City of Dayton
Economic Development Authority (EDA)
June 17, 2025
7:30 a.m.

To:	Jon Sevald	From:	Jason Quisberg, Engineering Nick Findley, Engineering
Project:	Telcom Concept Plan	Date:	May 27, 2025

Dayton Interchange Business Center, Preliminary Plat, Site Plan (Scannell)

SHEET
C3.01
3 OF 28
REV.

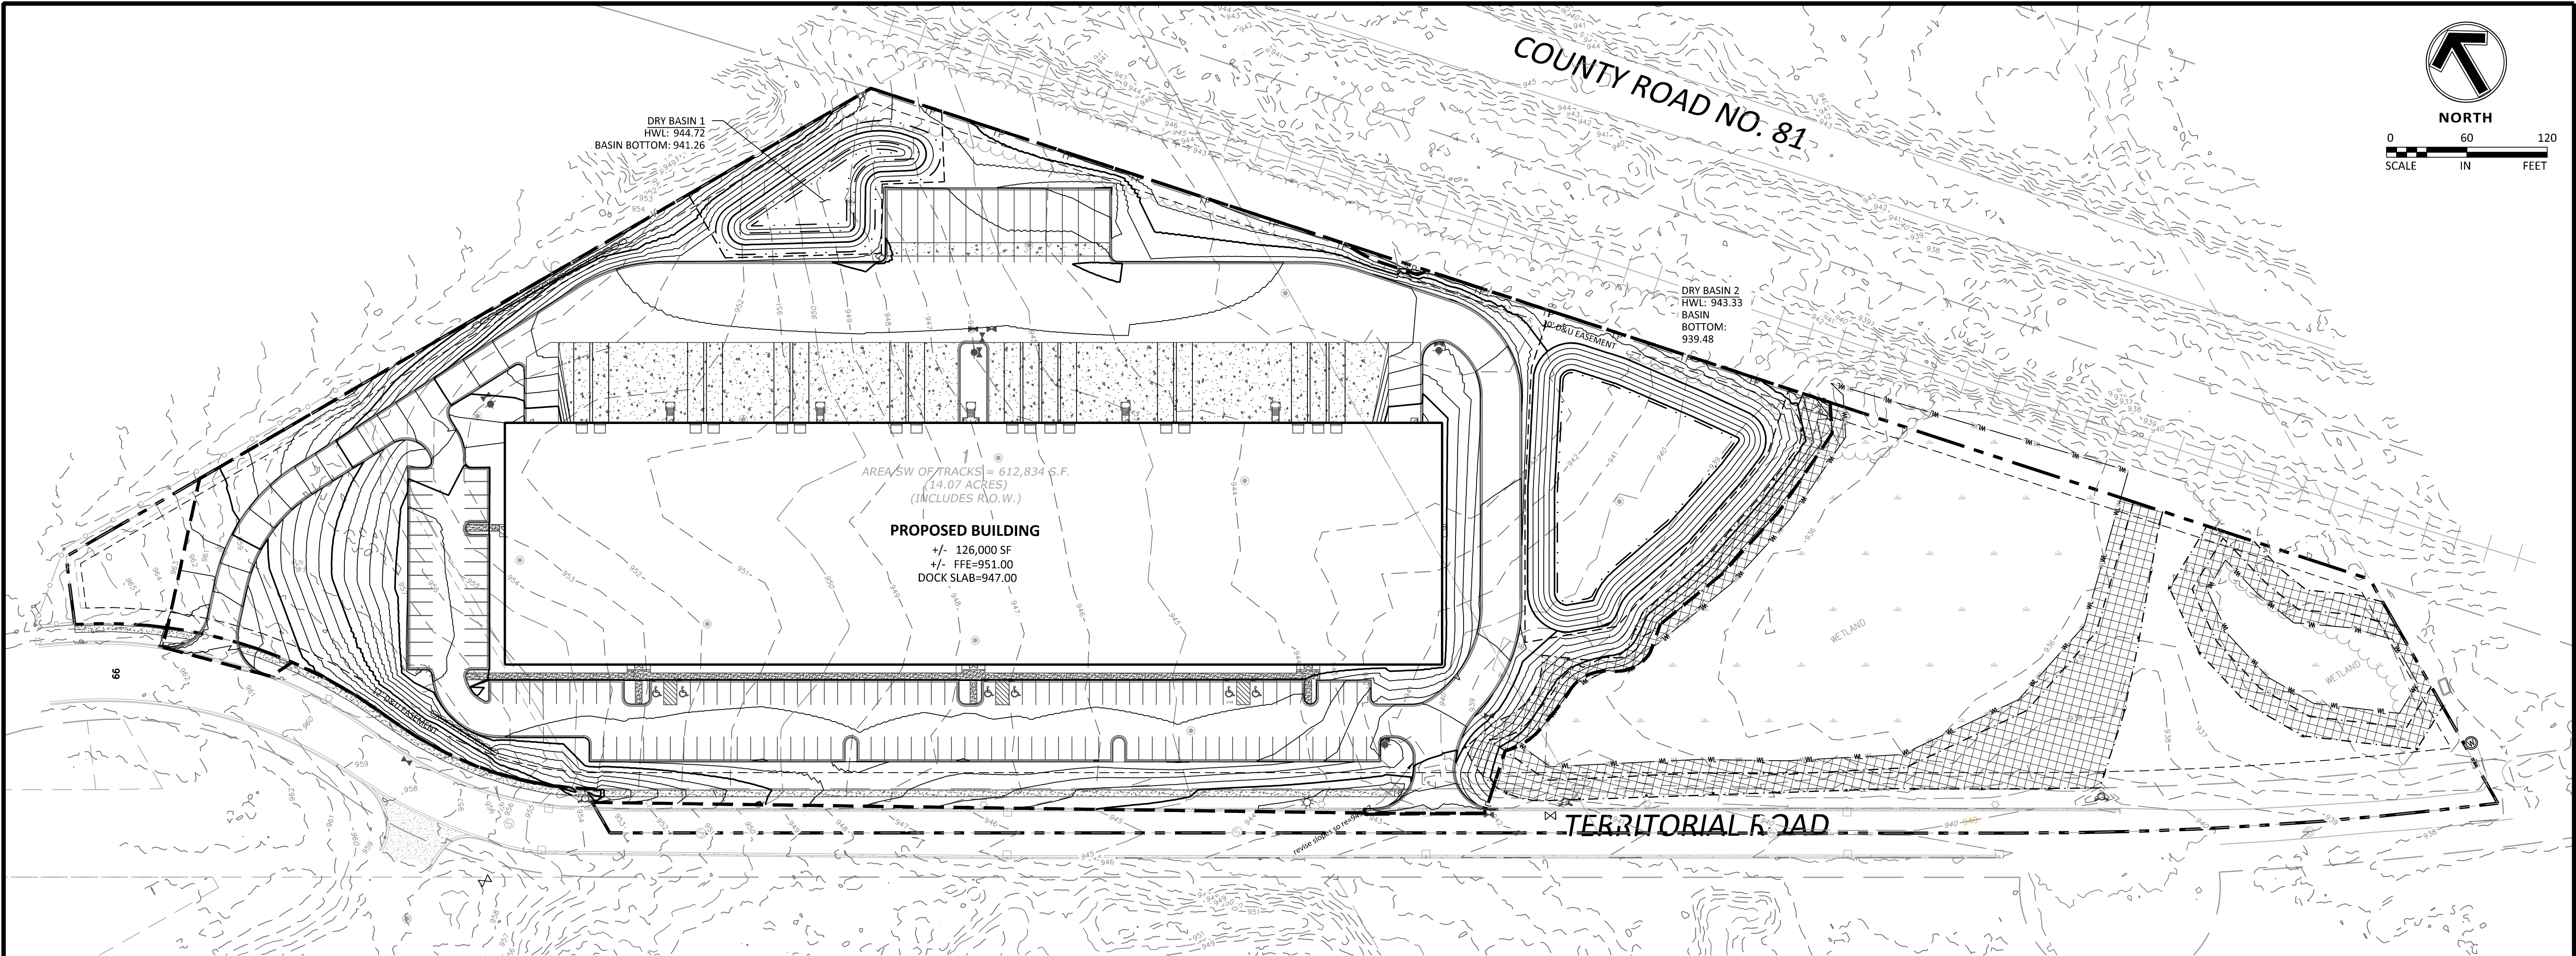
13. Provide stop signs where vehicles are to exit the site onto Territorial Road.
14. The eastern entrance is a different width than the western entrance. Provide additional information on the traffic configuration or other factors that caused the variance in width.
15. Revise hatching of driveway entrances to match the design laid out in the commercial concrete driveway apron with sidewalk standard detail plate.
16. The parking spaces appear to be out of compliance with the City Code. Some areas appear to impact pedestrian movement conflicting with the overhang requirements.

OVERALL GRADING PLAN

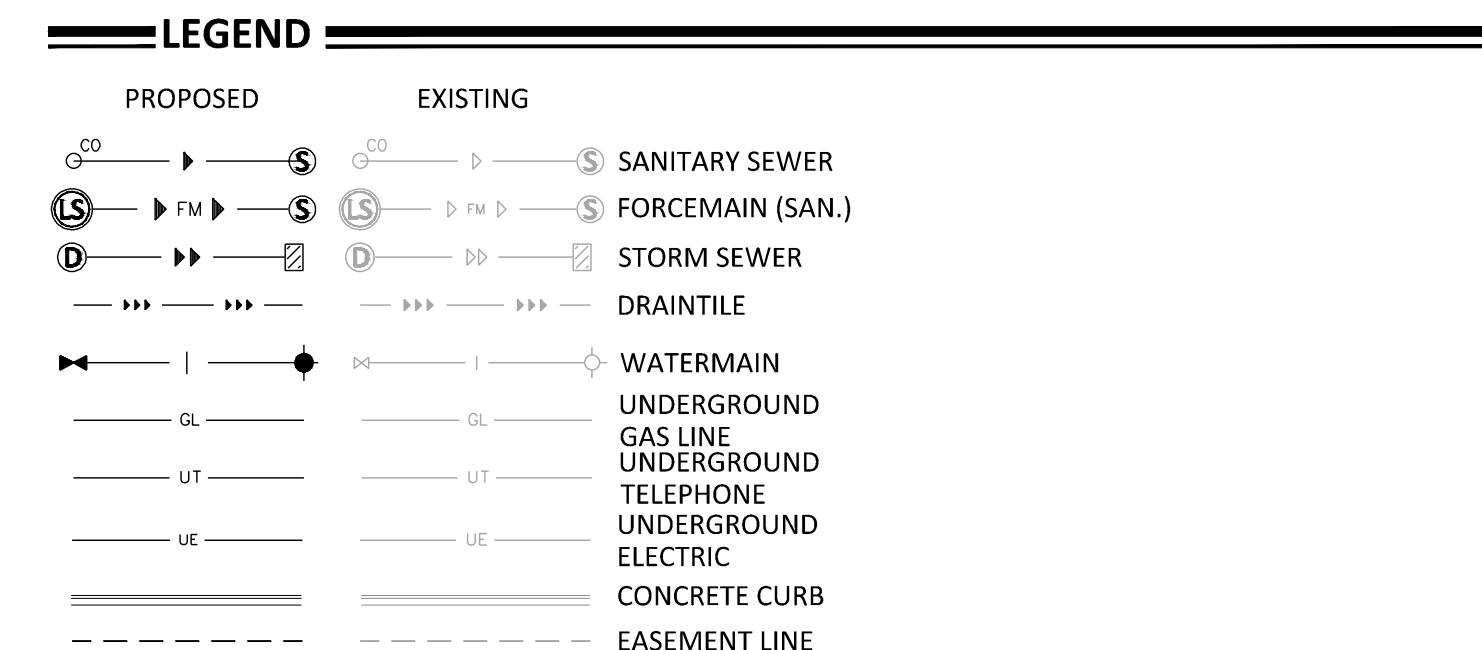
21. There are multiple instances where grading spot elevations do not line up with the corresponding rim elevations. Revise to ensure that the elevations are consistent across the plans.
 - a. Provide the catch basin location and rim elevations on the grading plan.

22. Grading does not tie in along the western edge of the site. Revise so all proposed contours tie into existing contours.
23. Provide details including spot elevations and slopes of the proposed pedestrian ramps showing they are within ADA compliance.
24. Ensure accessible stalls meet ADA grading requirements.
25. Grading is shown less than 0.1% in some locations along the curb line. A minimum of 0.5% slope should be maintained along curb lines and other impervious drainage paths to ensure proper drainage.
26. There are multiple locations where grading is shown within excess of 4:1 grading. It is recommended that areas to be maintained are 4:1 or slighter to allow for maintenance activities. The maximum allowed slope is 3:1.
27. Steep slopes are shown between the loading bay and proposed bituminous ramp into the building. A railing or other safety measure may be needed along the ramp.

28. Provide defined/graded overland EOF for both dry ponds and show/label on grading plans. EOF shall be 1 foot above HWL or higher.
29. Proposed drainage map watersheds are difficult to discern. Please bring subwatershed boundaries to the front of all other layers.
